Report of the CAA's Post Implementation Review of the London Airspace Management Programme (LAMP) Phase 1A Module A Airspace Change Proposal – London Stansted Airport Standard Instrument Departure (SID) Switch Proposal

CAP 1692 A

Published by the Civil Aviation Authority, 2018

Figure 9 - Heights of 22CLN departures through Hatfield Heath gate, 10 August and 12-17 August 2013

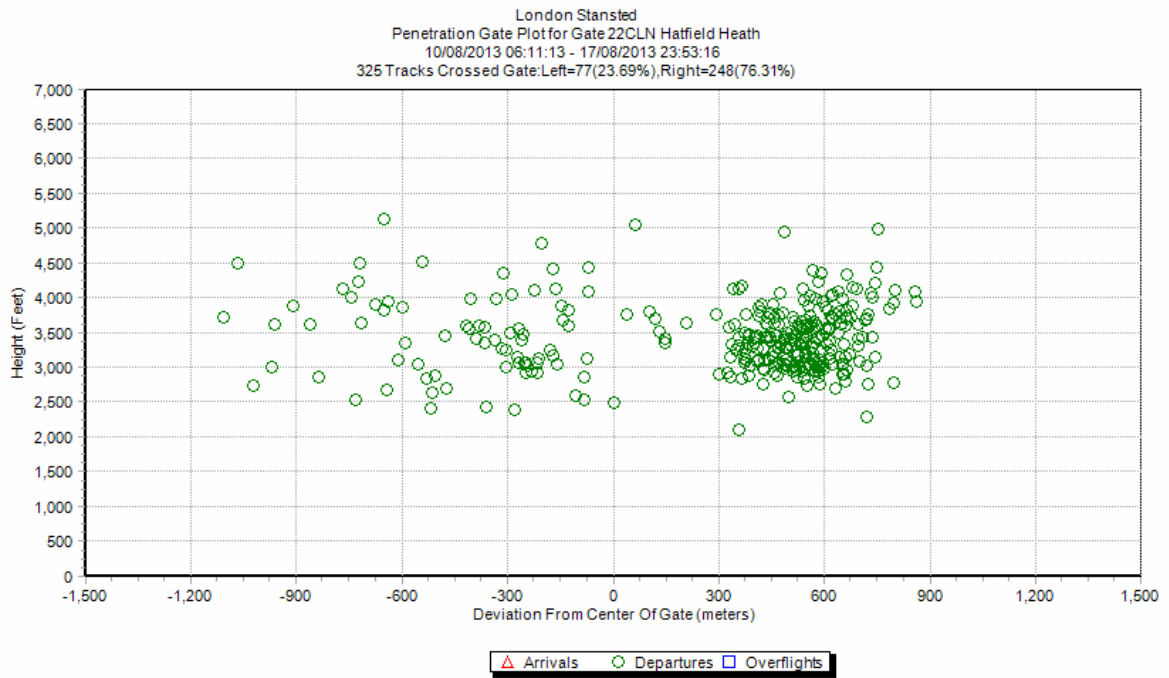
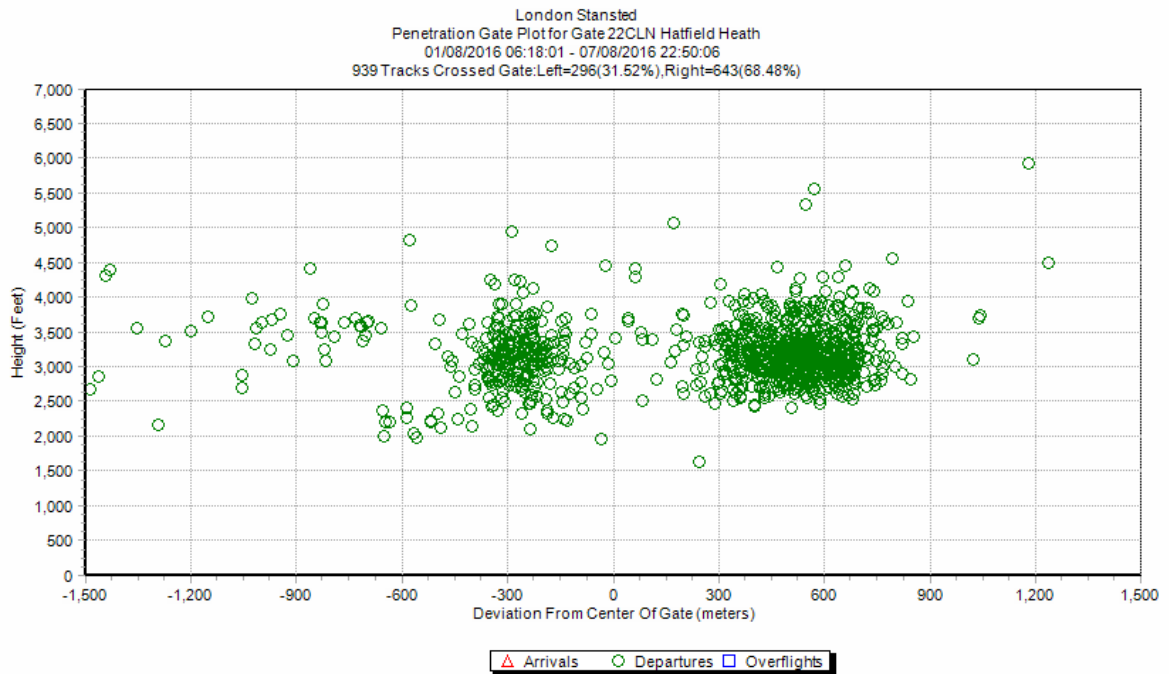
that shows the concentration of departing aircraft had moved closer to that community. (This supported by the Gate Analysis at Annex F of this report. Figures 9 and 10 of that Annex show a change in lateral spread, with a distinct “clump” that is likely to be the aircraft using the Trial RNP1 SID.) This aspect was not anticipated, but nor is it a result of the airspace change that this PIR is assessing.

On the Clacton Runway 22 SID, the data sample for August 2016 shows a slight shift in the concentration below 4000ft towards Hatfield Broad Oak. The data sample provided for the PIR was for 330 Clacton SIDs in August 2013 and 915 Clacton SIDs in August 2016. We have ascertained that 17% of Runway 22 Clacton departures in August 2016 were aircraft using the Trial RNP1 SID (see further detail in paragraph 19 of the main PIR Report) in use at that time. The evidence indicates that aircraft using that trial SID flew a tighter initial turn which results in a track that is further from Hatfield Heath but closer to Hatfield Broad Oak. On that basis, we believe that this aspect of the change in traffic pattern is likely to be due in large part to the proportion of departures in the August 2016 traffic sample that were using the Trial RNP1 SID.

Figure 15 - Average height and stage length (distance flown) of Ryanair 22CLN departures at High Easter gate during August

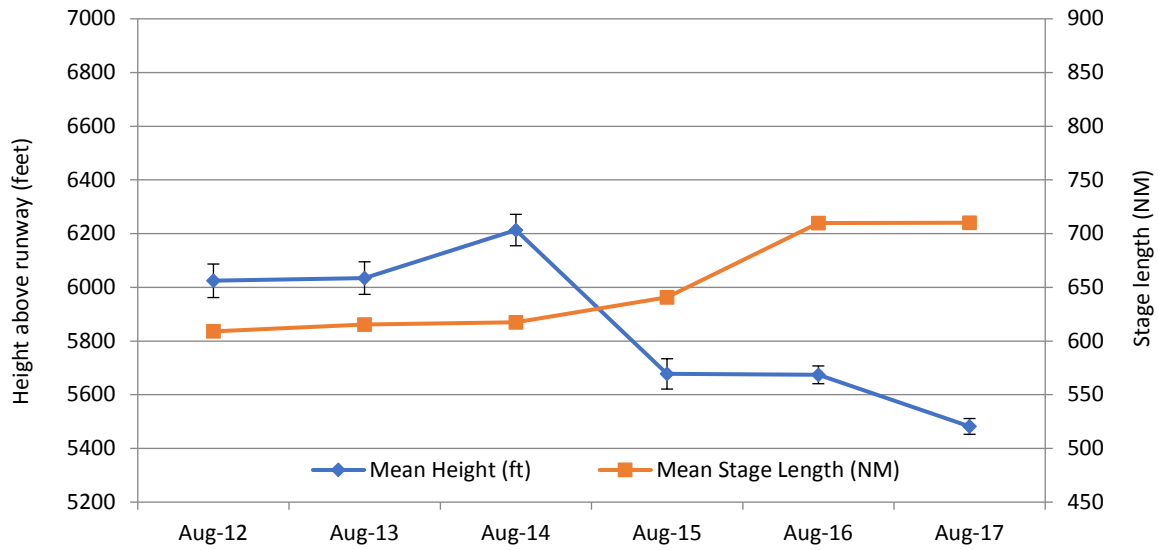
In order to test that possibility, ERCD looked more closely at one of the locations as an example (High Easter) to see if the reduction in average height occurred before the airspace change or afterwards, Figures 15 and 16 set out the results for Ryanair flights (the predominant operator at Stansted). The Figures illustrate that the average height of flights reduced in 2015, which is before the airspace change was implemented. This would suggest that any reduction in average height is not as a result of the airspace change itself but as a result of other factors, unrelated to the airspace change.
